Technical Service Bulletin (TSB)
RSU With Additional Sleep Cycles for HV Battery Integrity
Check - Flash: Battery Pack Control Module (BPCM) Updates 6A1

REFERENCE:	TSB: 08-081-25 REV. A GROUP: 08 - Electrical	Date:	April 29, 2025	REVISION:	—
VEHICLES AFFECTED:	2025 (LB) Dodge Charger This bulletin applies to vehicles built on or before **April 03, 2025 (MDH 0403XX)** equipped with 400V G2500 FR/RR Elec Drive Motors (Sales Code ELD).			MARKET APPLICABILITY: ☒ NA☒ MEA ☒ SA☒ IAP ☒ EE☒ CH	
CUSTOMER SYMPTOM:	Customers may experience a Malfunction Indicator Lamp (MIL) illumination and the vehicle may exhibit/set one or more the following Diagnostic Trouble Codes (DTCs): **P0DE6 - Hybrid/EV Battery Pack Cell Voltage Low. NOTE: Active or stored. - P1DAF - Incompatible Limp In Action Requested. NOTE: Active or stored. - P1CDE – Hybrid/EV Wakeup Control 2 Output Circuit Short to Ground. - P1CDA – Hybrid/EV Wakeup Control 1 Output Circuit/Open. - U00C6 – Lost Communication With AIR Pressure Sensor. - P0F00 - Hybrid/EV Battery Module 1 Performance. - P0F01 - Hybrid/EV Battery Module 2 Performance. - P0F02 - Hybrid/EV Battery Module 3 Performance. - P0F03 - Hybrid/EV Battery Module 4 Performan

Fig. 1
Cooling Fan Assembly

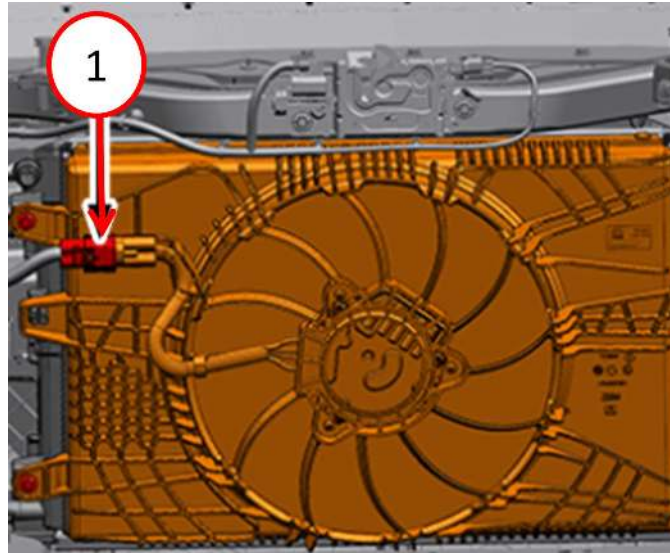
NOTE: The cooling fan must be disconnected to prevent it from powering on, which may interrupt/ abort the flash process.
4. Disconnect the cooling fan wire harness connector [Fig. 1](#).

26. Connect the cooling fan wire harness connector [Fig. 1](#).

Fig. 3
#38 AGSM Fuse Location

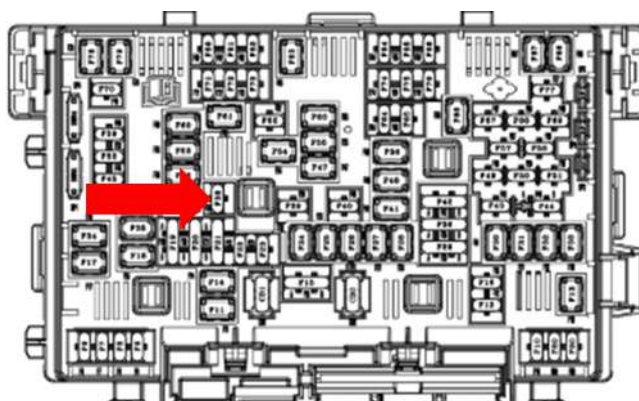
Failure to remove the #38 AGSM fuse will result in damage to the shifter.

6. Remove the PDC cover, locate and remove the #38 AGSM fuse [Fig. 3](#).**

24. **Install the #38 AGSM fuse [Fig. 3](#) and the PDC cover [Fig. 2](#).
